Work Order ID 128370

Item Name: Quick Release Basket Mounting Spacepod™ & Squirrel Cheek Fits LH or RH

DART SERVICE INSTRUCTION

TO AMEND INSTALLATION INSTRUCTIONS D350-607-3 Rev.D,
INSTALLATION INSTRUCTIONS D350-607-4 Rev. C AND
INSTRUCTIONS FOR CONTINUED AIRWORTHINESS ICA-D350-607 REV. 6
REF TCCA STC: SH94-14
REF FAA STC: SR00213NY
REF EASA STC: EASA.10016996
REF BRAZILIAN STC: 2007S03-03/-04/-05/-06

FIGURE 1: INSTALLATION OF D4775-041 FWD STRUT

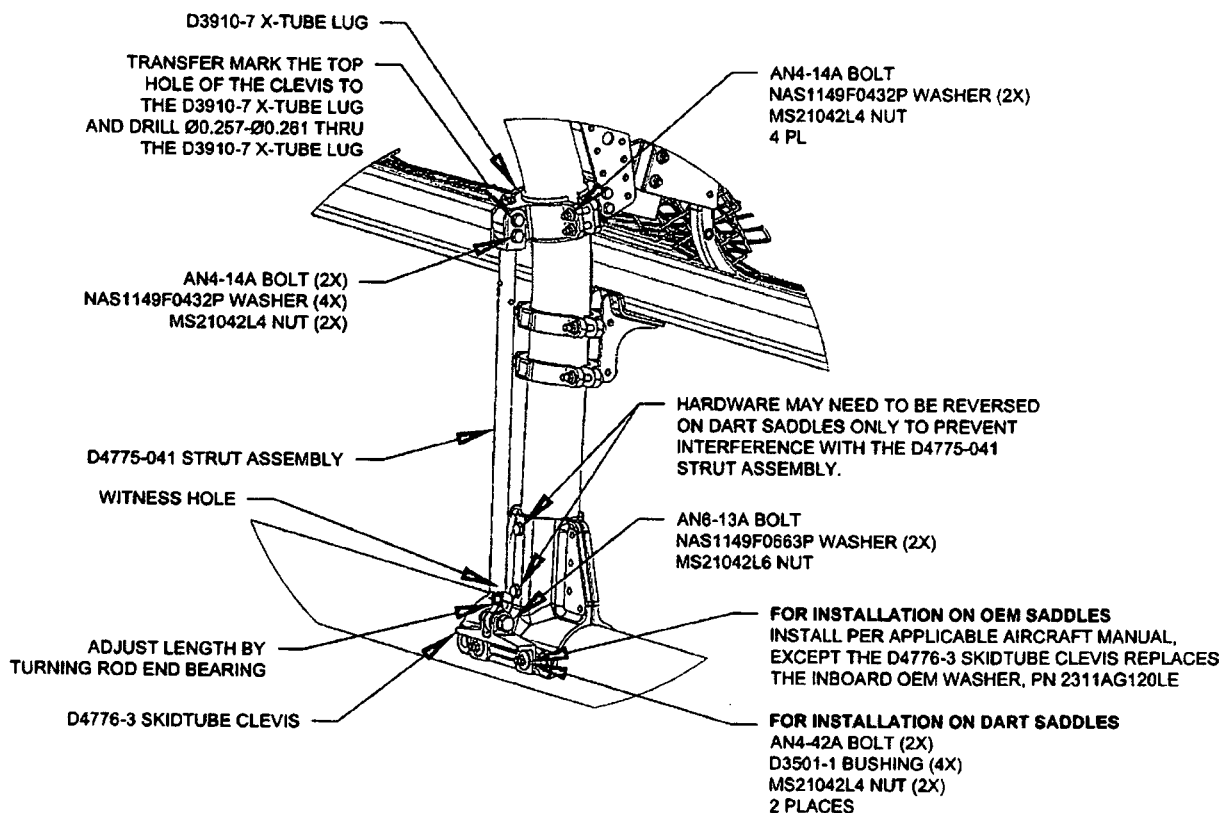
- 3.1 Substitute the Forward Lower D3910-5 X-Tube Lug with the D3910-7 X-Tube Lug as shown in Figure 1.
- 3.2 Install the forward D4775-041 Strut Assembly. Transfer mark from the upper hole on the clevis of the D4775-041 Strut Assembly to the D3910-7 X-tube Lug and drill thru the lug $\varnothing 0.257$ - $\varnothing 0.261$ as shown in Figure 1. Touch up chemical conversion coating per MIL-DTL-5541. Check the witness holes located at the bottom end of the D4775-041 Strut Assemblies to ensure that the thread from the rod end extends past the witness hole.
Torque MS21042L4/-4 nuts to 50-70 in-lbs (5.7-7.9 N-m). Torque MS21042L6/-6 nuts to 160-190 in-lbs (18.1-21.5 N-m).
- 3.3 Complete the installation in accordance with Installation Instructions D350-607-3 Rev. D or D350-607-4 Rev. C.
